ORIGINATION FORM

Proposed Revisions to a Standard Plans Index

Index Number: 102-200

Index Title: TEMPORARY ACROW 300 SERIES DETOUR
BRIDGE GENERAL NOTES AND DETAILS

INDEX	SHEET
102-200	4 of 7

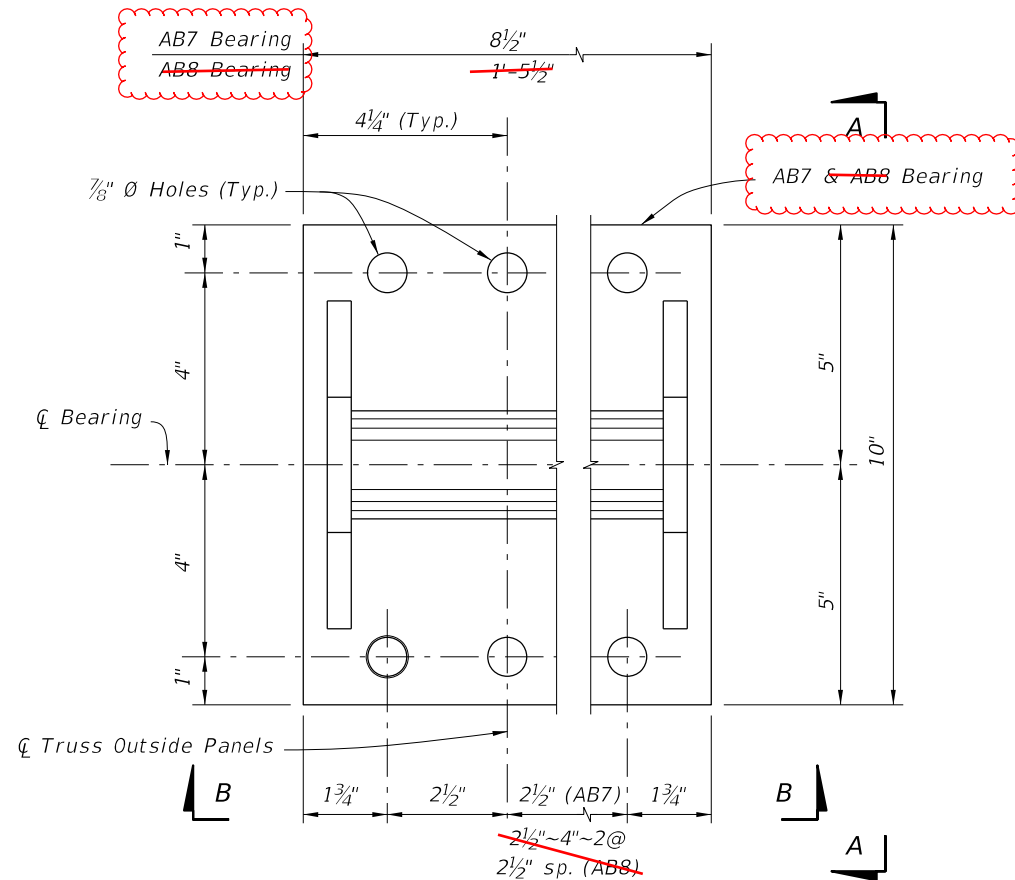
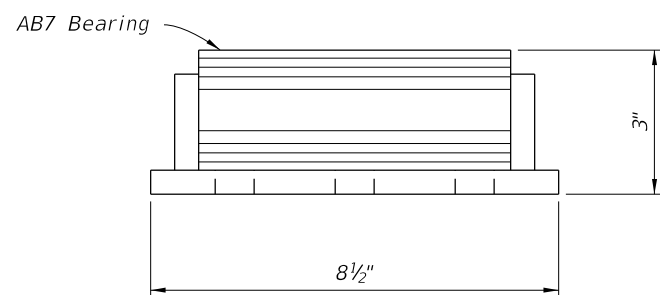
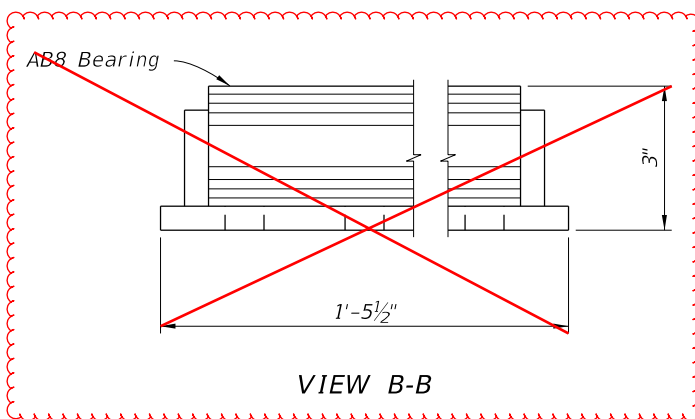
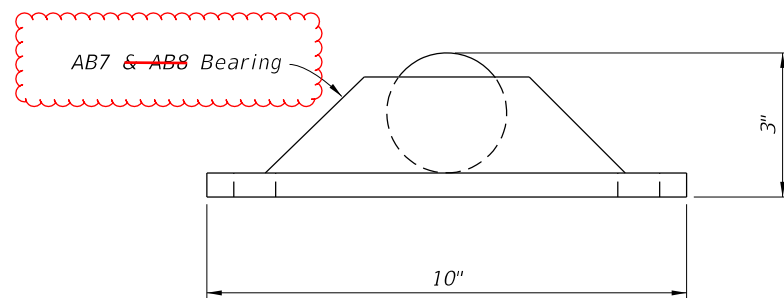
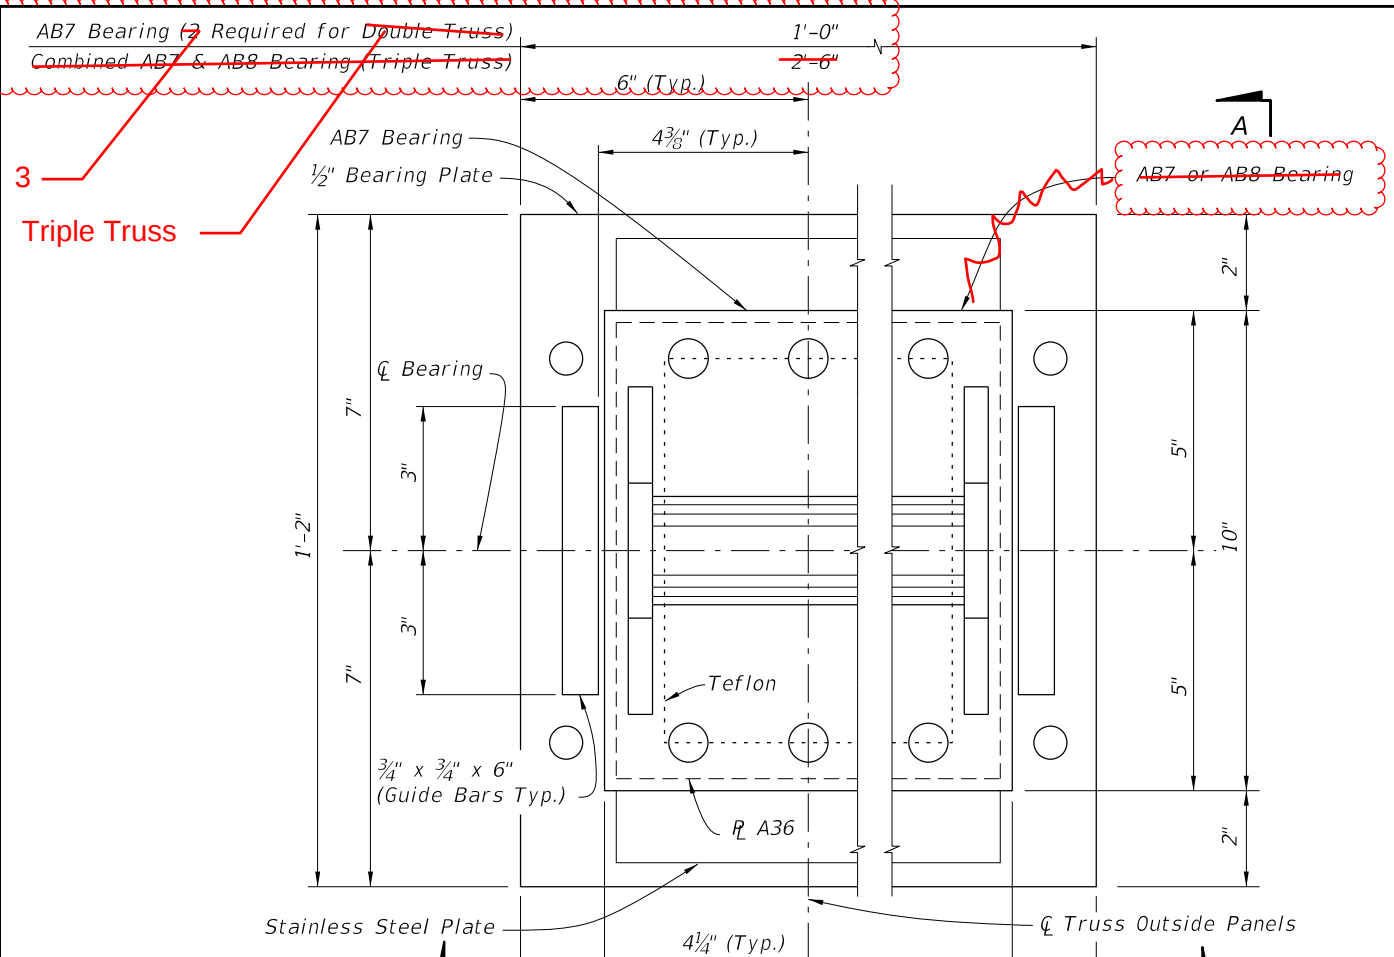
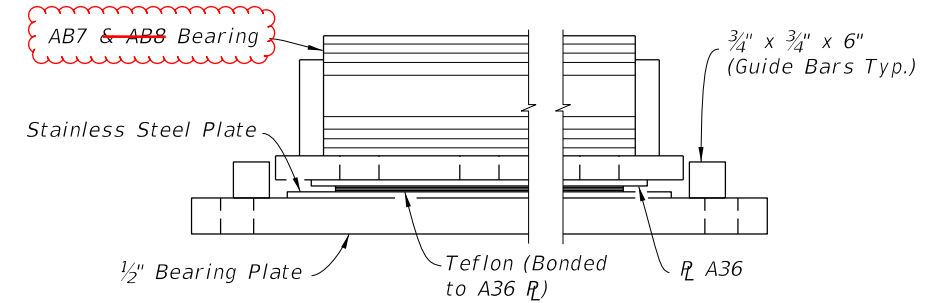
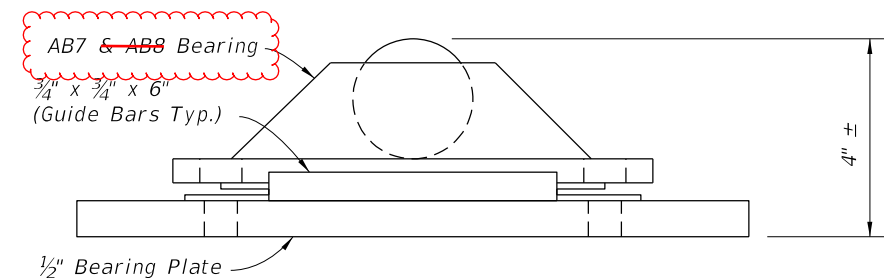
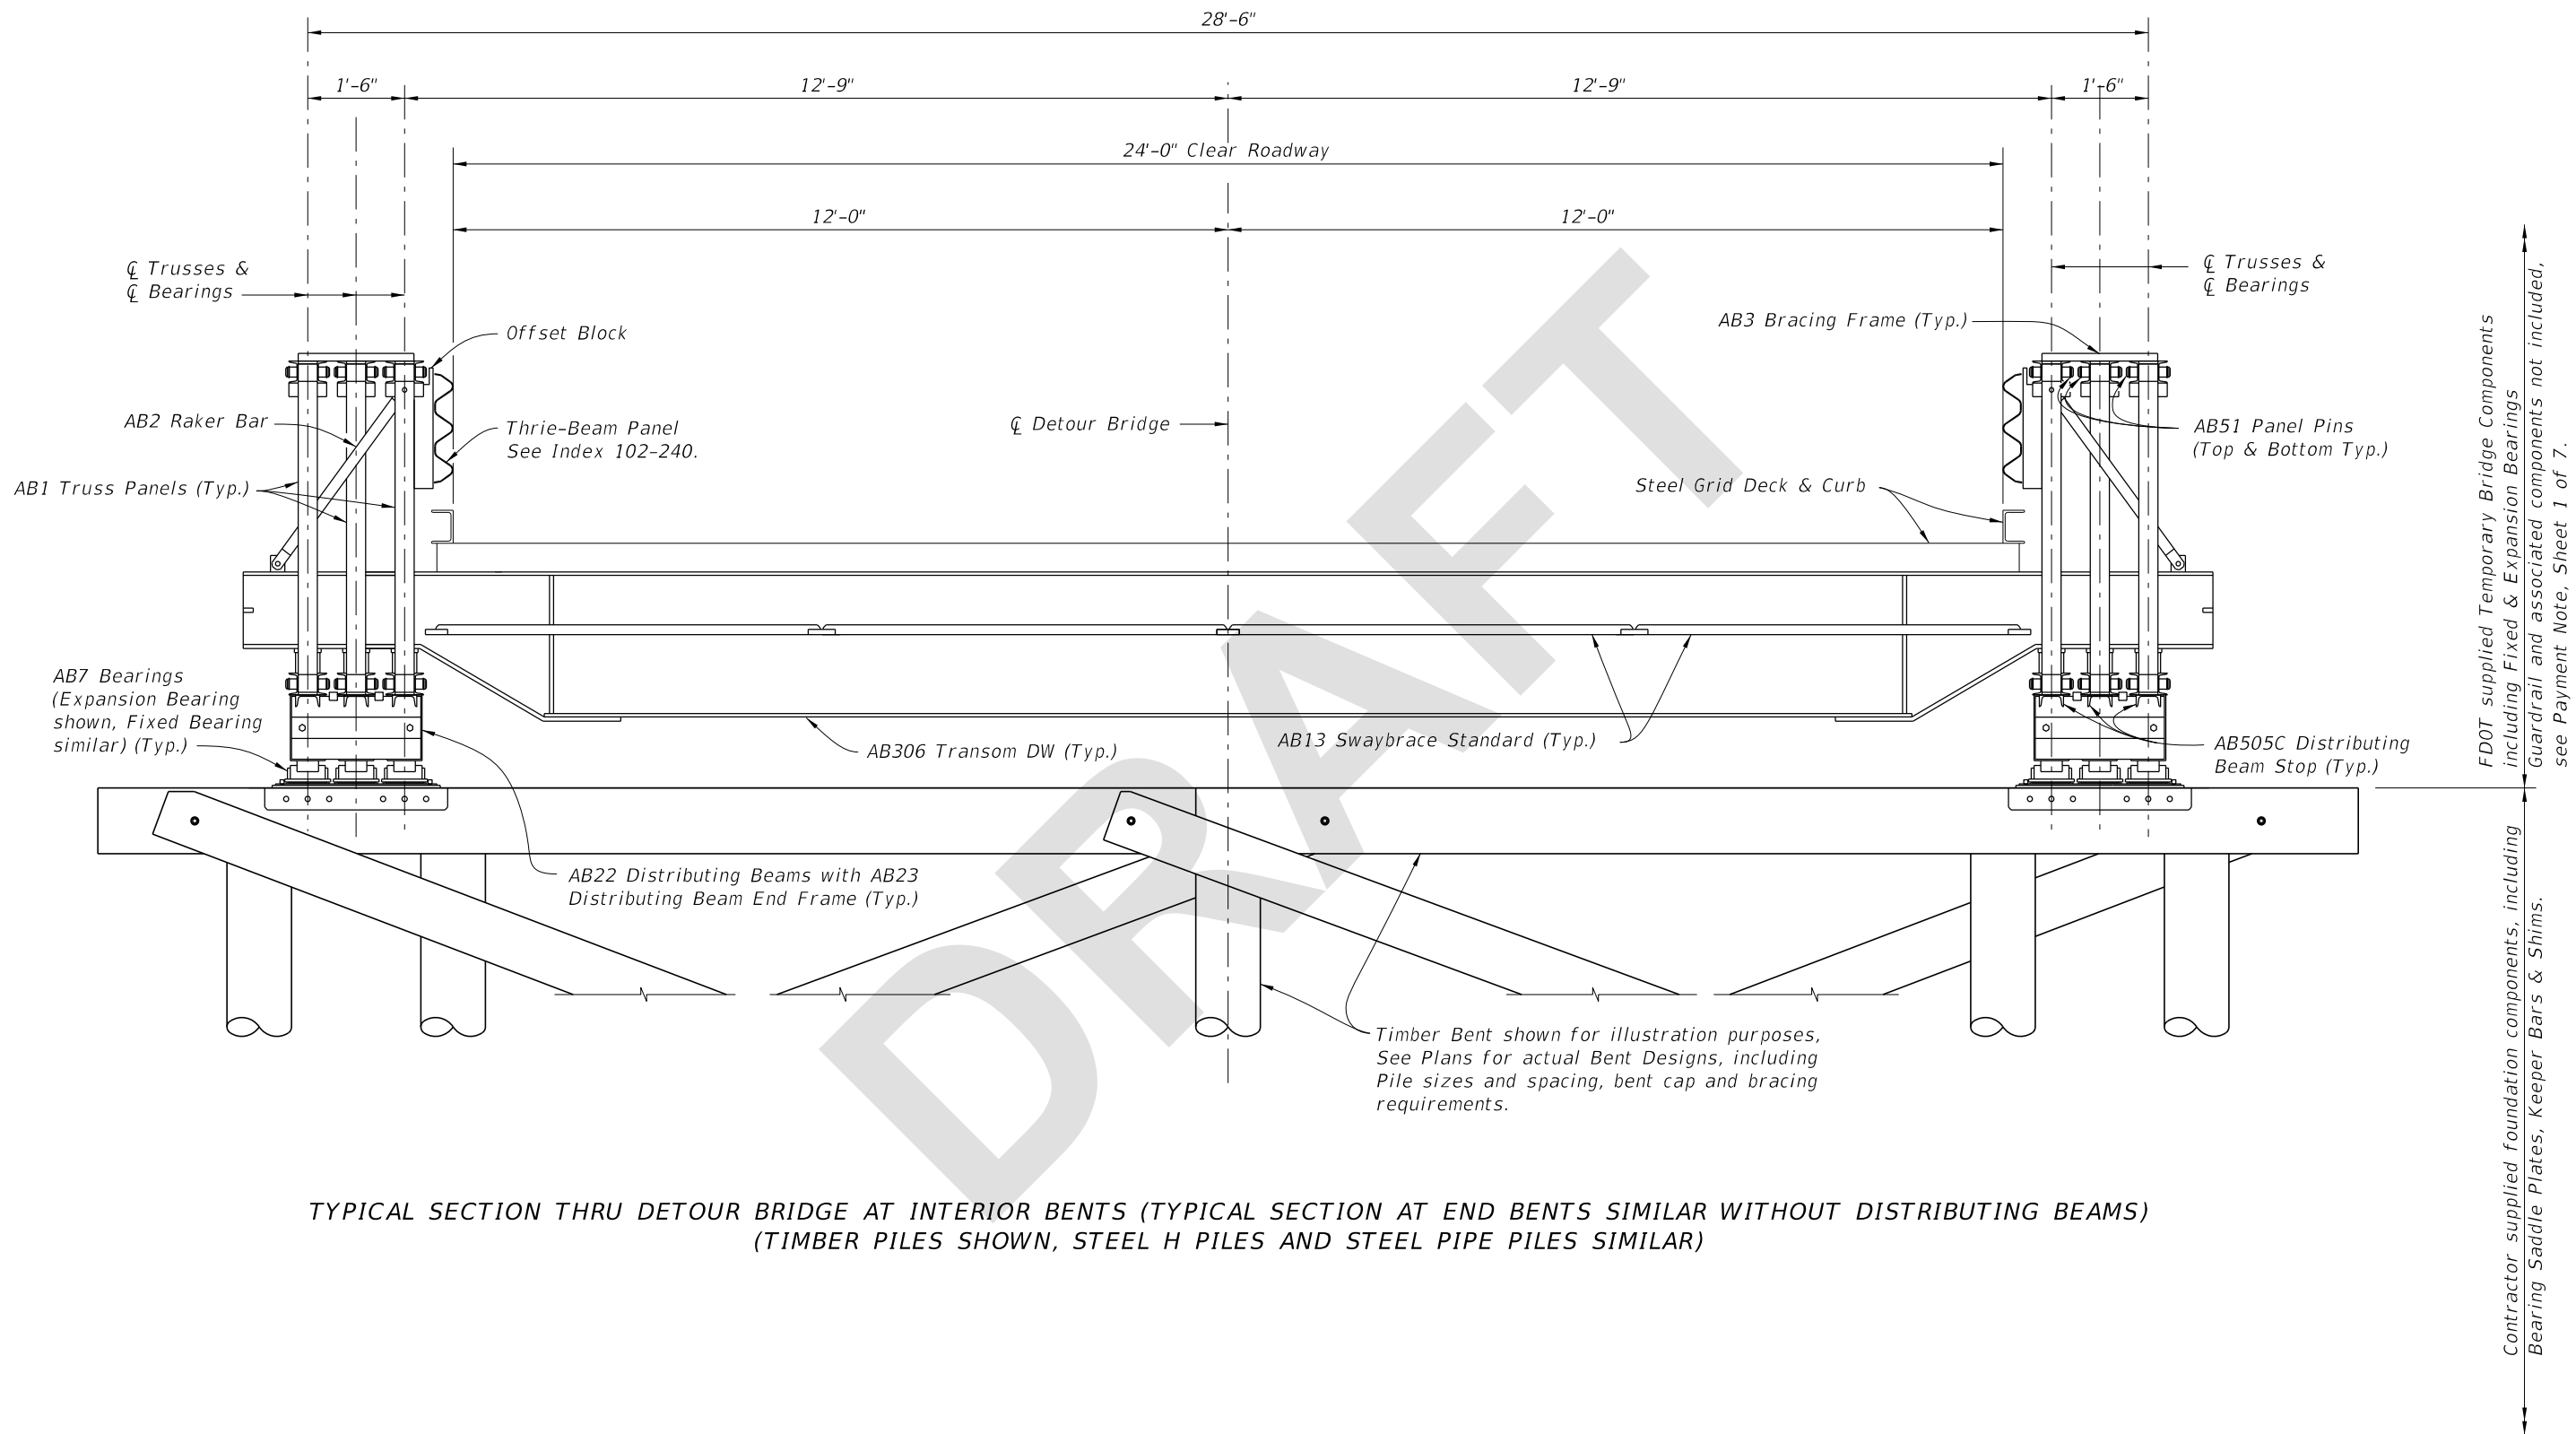
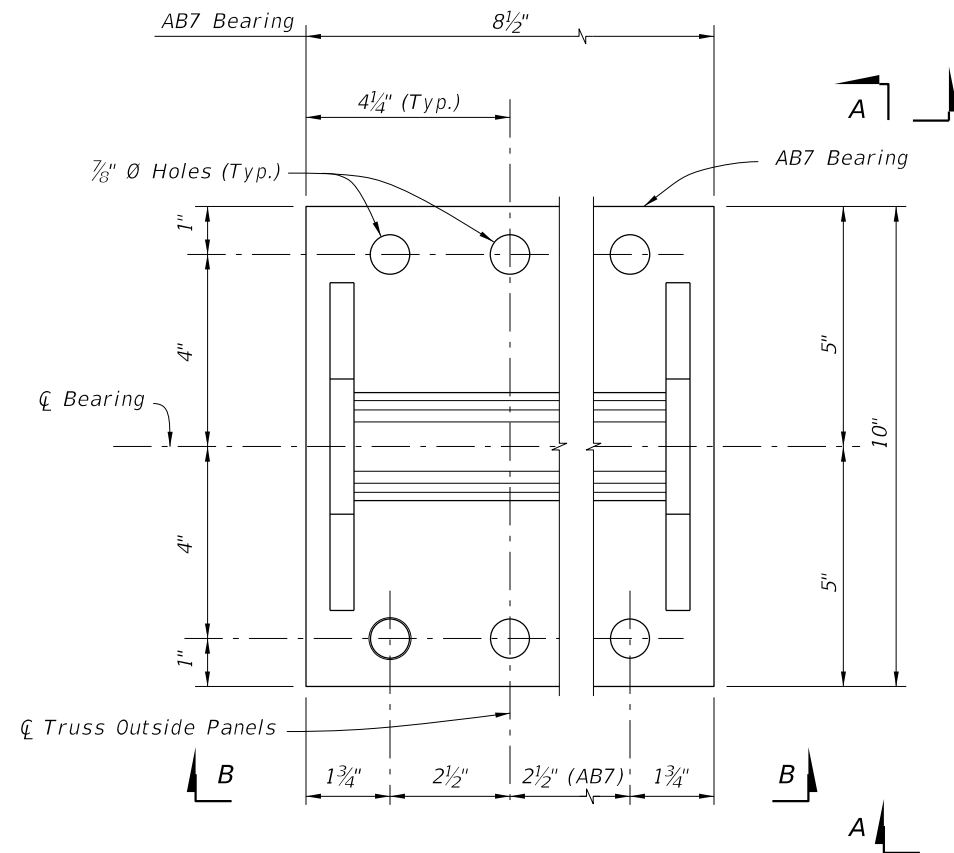
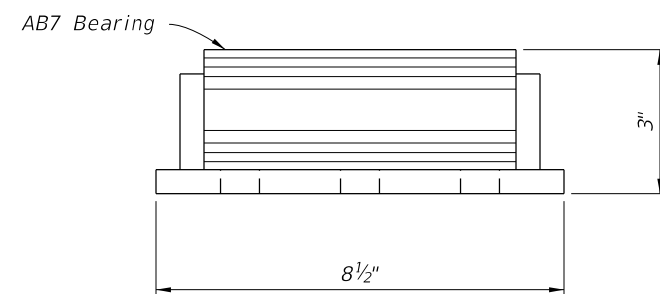
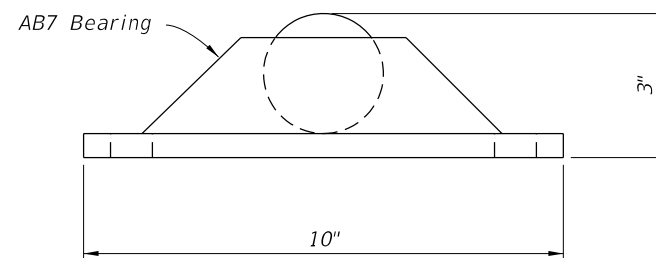
Sheet 4: Removed double bearing notes and details.

Sheet 5: Removed double bearing notes and details.

Sheet2-6: Currently FDOT only has single bearings in inventory.
